**Request for Renewal of  
IP 0001/06 (IPPC Permit for  
Ghallis)**

**MEPA Review May 2012**

**WSM Reply June 2012**

Project: **GHALI'S CELL PROPOSED EXCAVATION - PLAN**

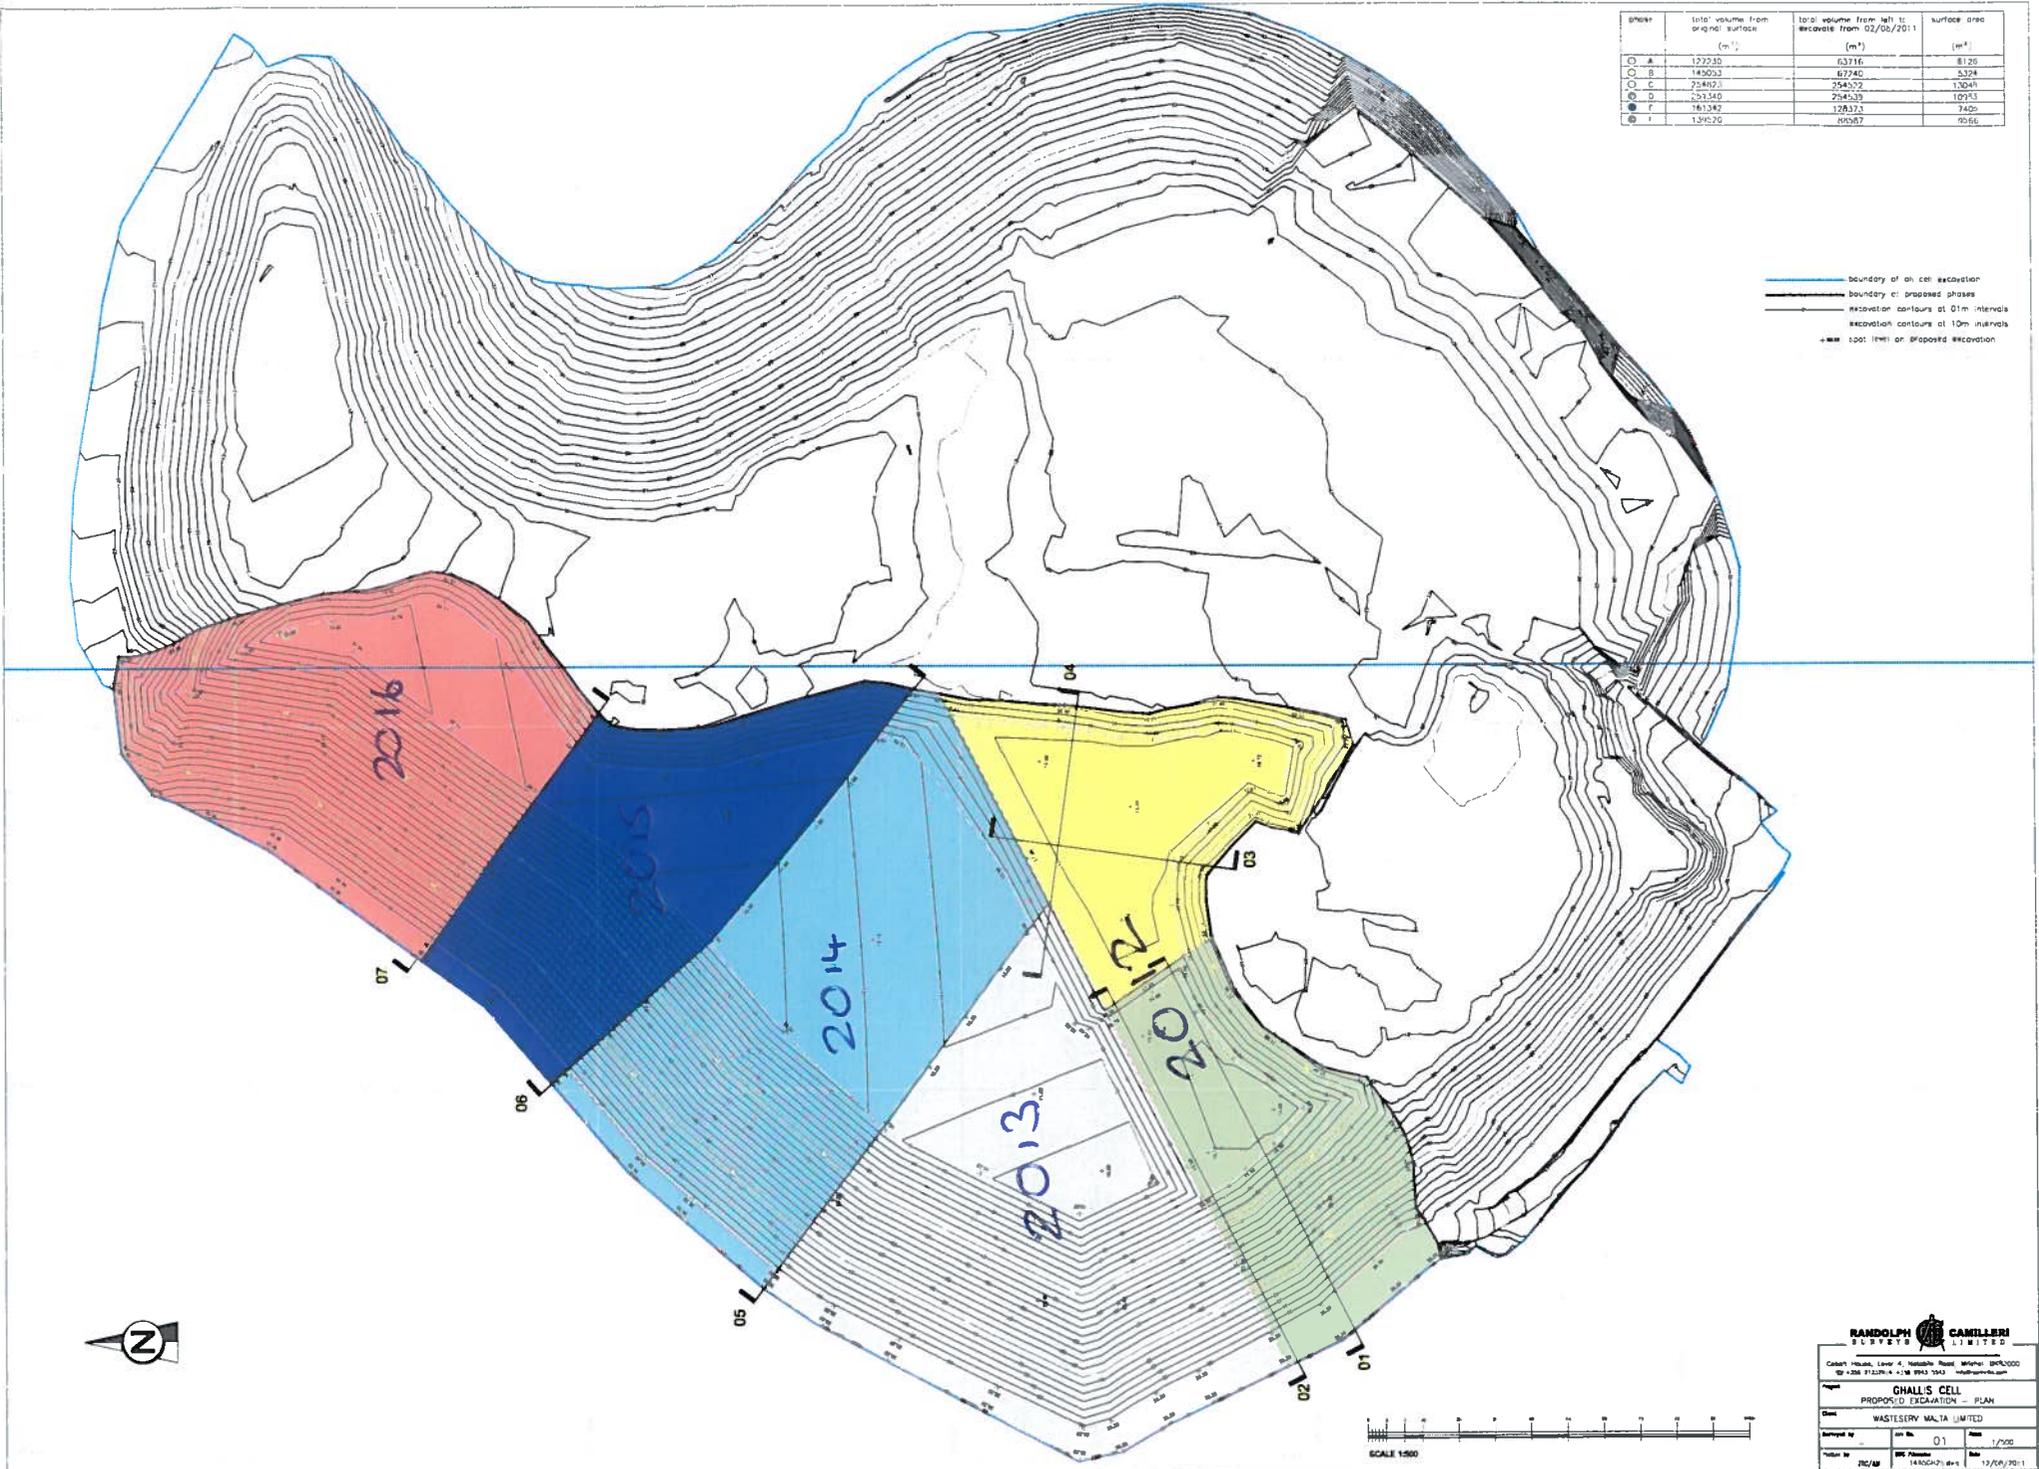
Reference	Further information required	Reply WSM June 2012
Annex 1	<p>(i) <i>Inspection and maintenance contract:</i> In the Site Management System document submitted as part of the original IPPC application, section 13.3 (Sub-Surface Structures) makes reference to an inspection and maintenance programme. Kindly provide a copy of this programme, together with any results of previous inspections/maintenance sessions (checks had to be undertaken at maximum 3 yearly intervals);</p> <p>(ii) <i>Final version of closure plan:</i> Kindly provide a timeframe for the submission of this plan;</p> <p>(iii) <i>Tipping design for Ghallis:</i> Reply (June 2009) to MEPA memo on compliance with permitting issues states that a tipping design for the landfill had to be incorporated as part of the closure plan (which was to be submitted by end of March 2010). Kindly submit a copy of the tipping design for this site.</p>	<p>(i) Feedback submitted in June 2009 WSM informed MEPA that this item is relevant to pipework, etc. in connection with the landfill gas management system. Since this is not fully in place an inspection and maintenance contract is not yet in place.</p> <p>(ii) By end 2013</p> <p>(iii) WSM's understanding is that MEPA would like to be informed how the different cells of the landfill will be filled and the final outline. Kindly refer to drawing in Annex 1 to this submission; this shows how the development of the landfill shall proceed over the next few years. Infilling of the new cells shall occur in the same order but not necessarily at the rate indicated.</p>
